Great Wolf Lodge, Chesterton, Bicester
Great Lakes UK Limited

Design & Access Statement Addendum

December 2021

2.1 Key Changes and Benefits

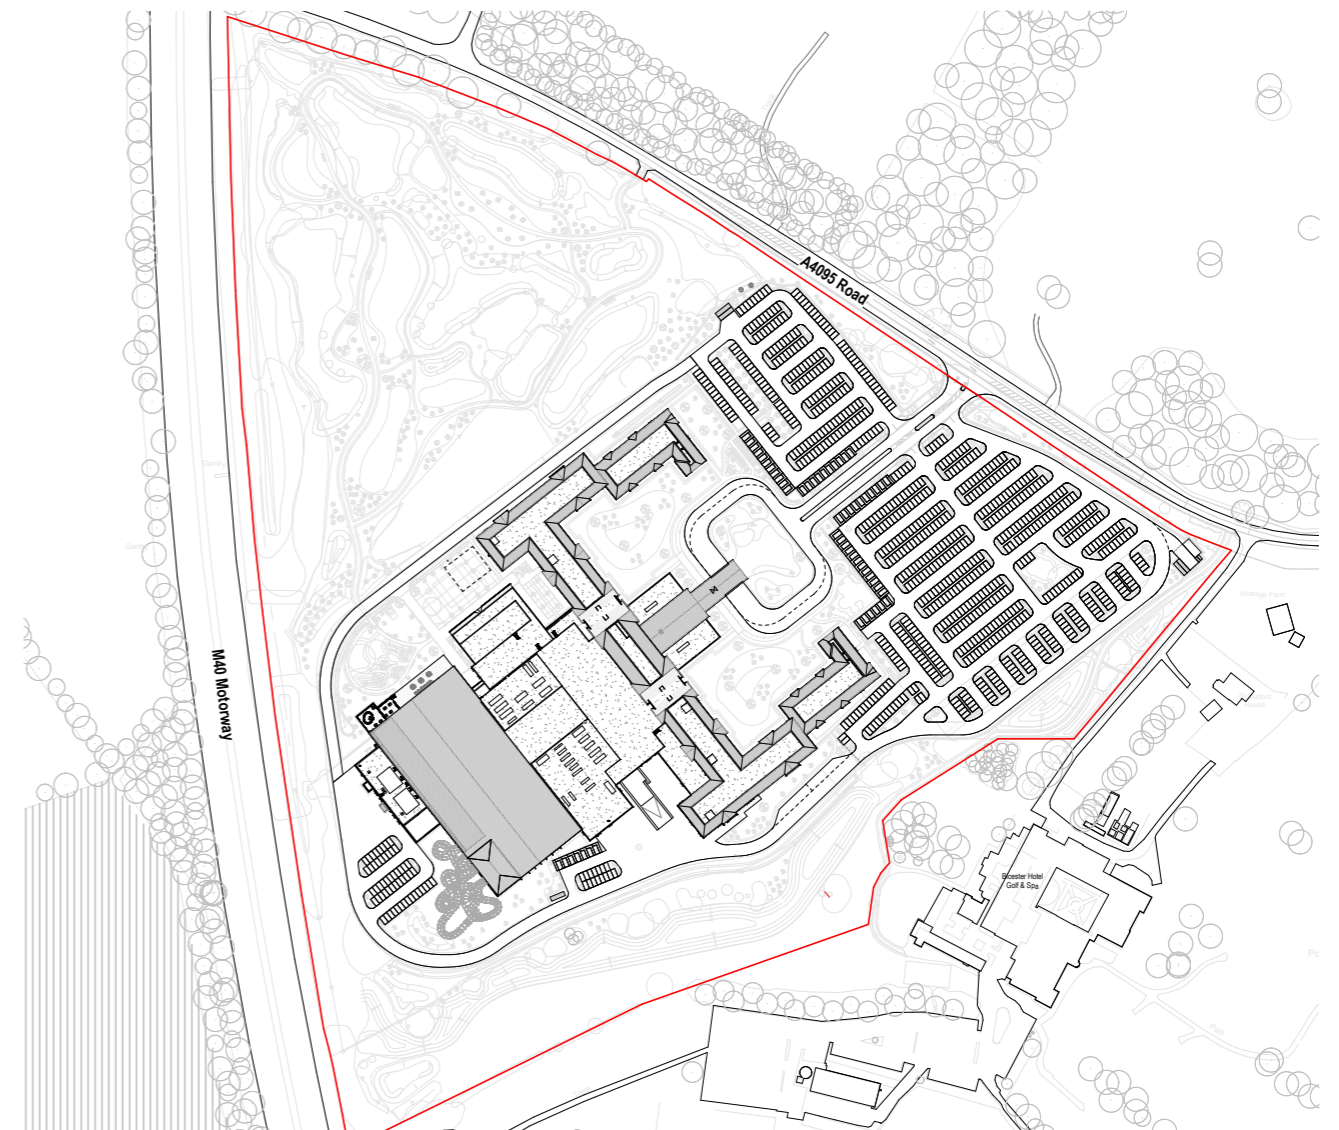
The design updates presented within this report are primarily a result of detailed design development as part of RIBA Workstage 3. The key updates involve the reduction in the overall size of the FEC building resulting in a shift of the guestroom u-shaped tower southwards by approx 3.6m, whilst the footprint of the waterpark remains the same as the consented scheme. There are no material changes to the envelope design of the consented building. All proposed shifts have been updated in line with the massing and height principals set within the original application.

1. Alterations to the number and type of leisure attractions in the FEC.
2. Reconfiguration of the Conference centre orientation and floor plan to consolidate the guest experience and improve internal circulation.

3. General internal spatial co-ordination in line with operational requirements. Generally, this is local to internal layouts but do affect a small number of external door and window positions.

4. Updates to the landscape design proposal as a result of the building footprint changes and reconfiguration of the Conference centre and fire tender access to the site.

5. Extension of the Porte cochere as a result of shifting the building southwards 3.6m to allow for a larger drop off / set down point for arriving guest vehicles/buses.

6. Waterpark updates including slide and external terrace paving area modifications. The overall height of the waterslide is maintained below the height of the turret which remains as per the consented scheme.

7. Relocation of Great Wolf entrance statue.
8. Roof updates in line with revised roof access strategy.
9. Minor MEP and utility updates across the site.

10. Waste yard ramp dimensions updated with wider radius ramp and integrated vehicular protection zones.

2.2 Consented Scheme Comparison Proposed Scheme - Ground Floor

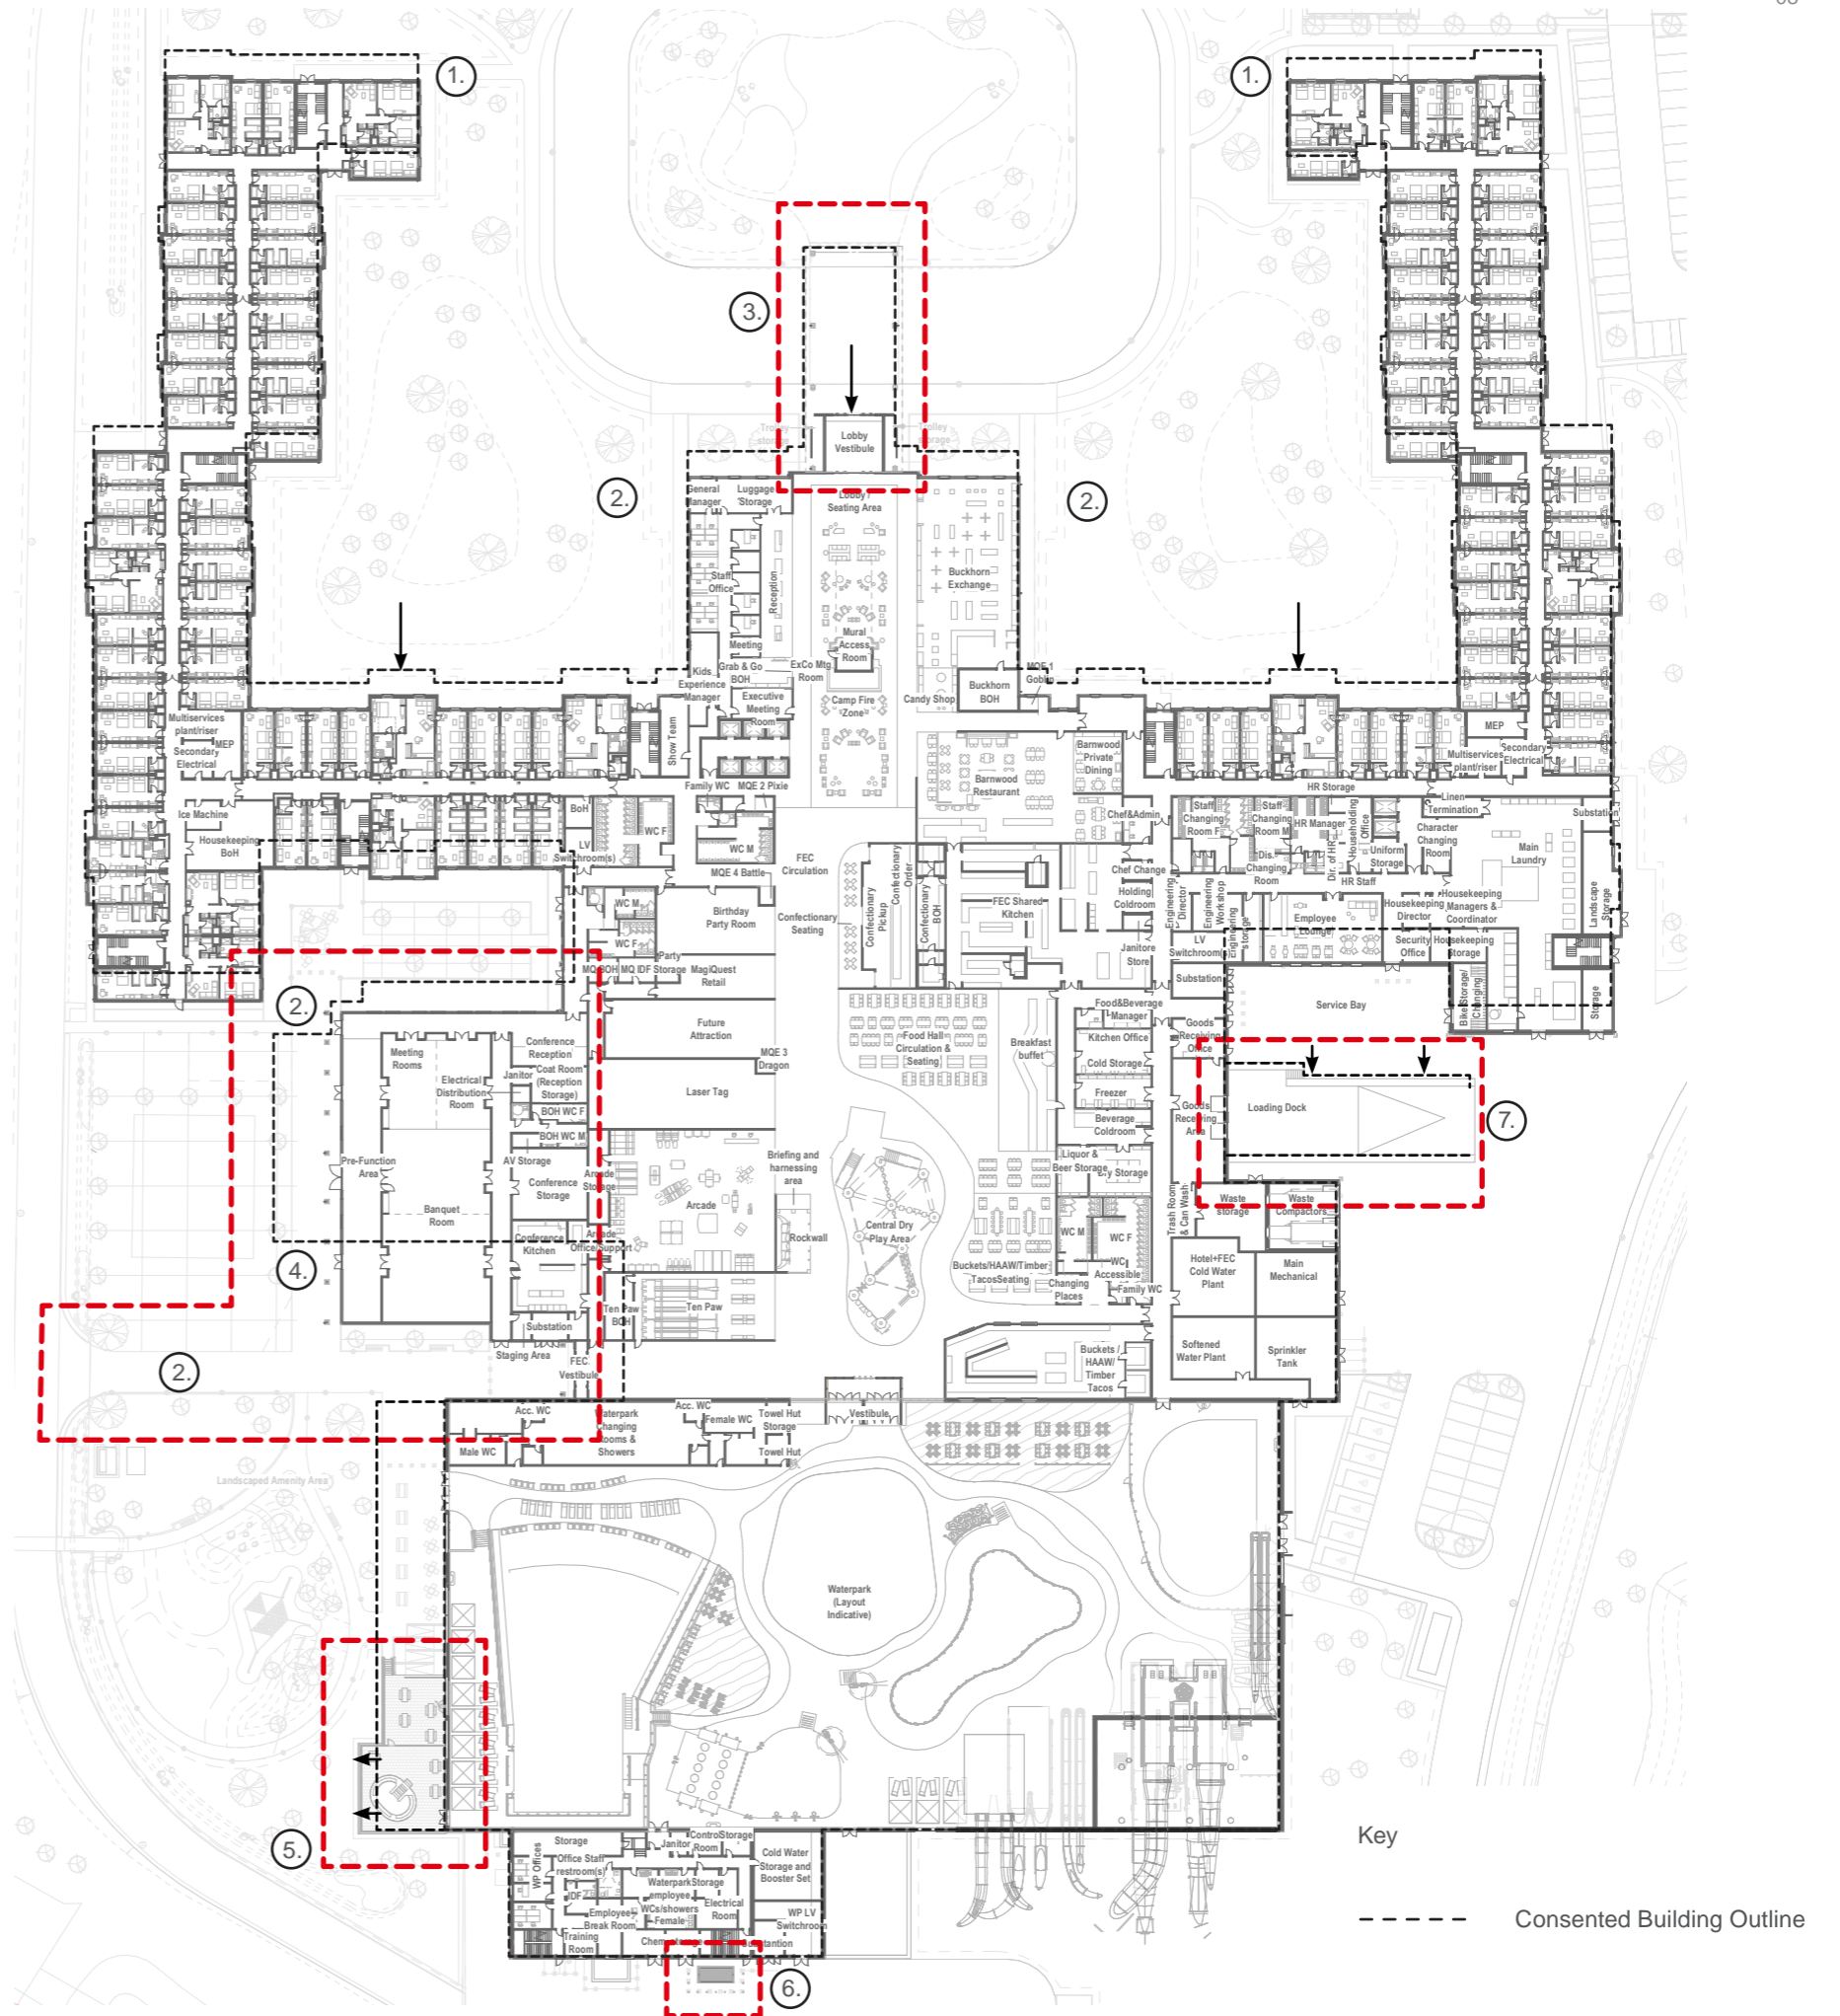
1. Reduction in the overall size of the FEC resulting in a shift of the guestroom u-shaped tower southwards by approx. 3.6m.
2. Updates to the landscape design proposal as a result of the building footprint changes and reconfiguration of the Conference centre and fire tender access to the site. I.e. Conference centre road split off from the perimeter access road moved in line with revised conference centre design.

3. Extension of the Porte cochere as a result of shifting the building southwards 3.6m. Updates made to create a larger drop off/set down point for arriving guest vehicles and shuttle buses. Refer to page 13 for details.

4. Re-configuration of the conference centre massing, facade design and internal layout.
5. External water park deck layouts revised and height levels updated to facilitate raised terrace zone with associated balustrade. Enlargened square to the South East corner created to host new outdoor whirlpool design.

6. External exposed Co2 storage tank to be located outside the proposed bunker building. Storage tank to be sat on a concrete plinth with perimeter bollards.

7. Waste yard loading bay ramp shifted 500mm closer to building envelope and concrete vehicular guarding added. Ramp increased in length.

2.2 Consented Scheme Comparison Proposed Scheme - First Floor

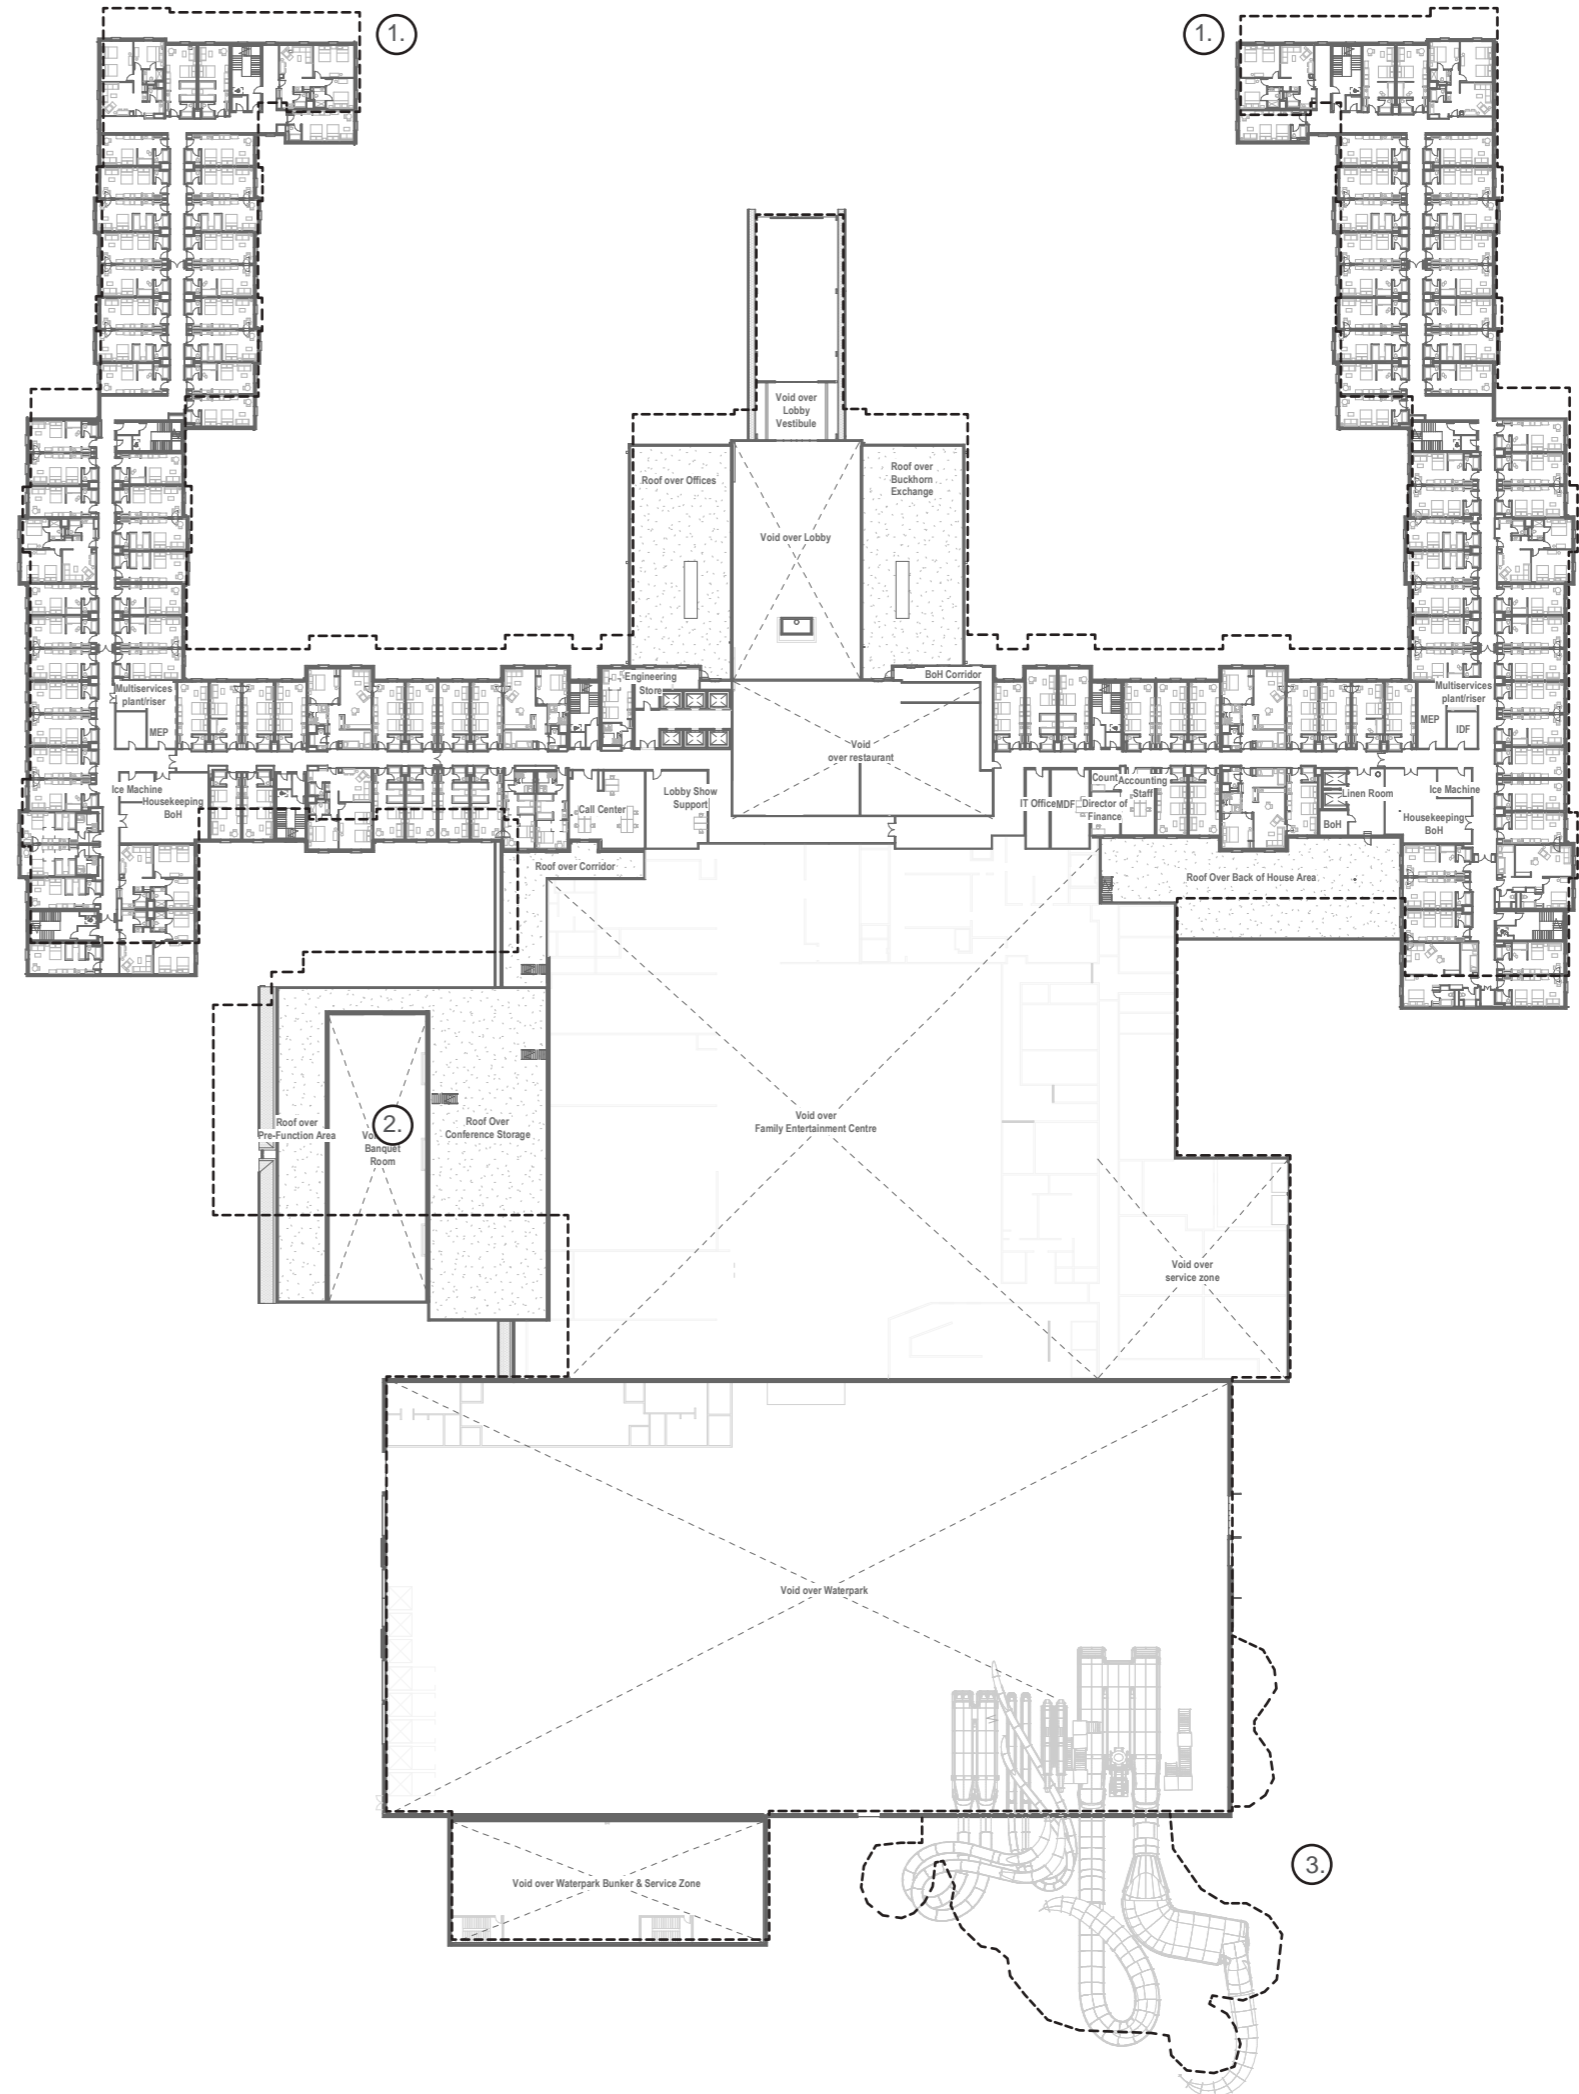
- ① Reduction in the overall size of the FEC resulting in a shift of the guestroom u-shaped tower southwards by approx. 3.6m.
- ② Re-configuration of the conference centre massing, facade design and internal layout.
- ③ Water slide design updated.
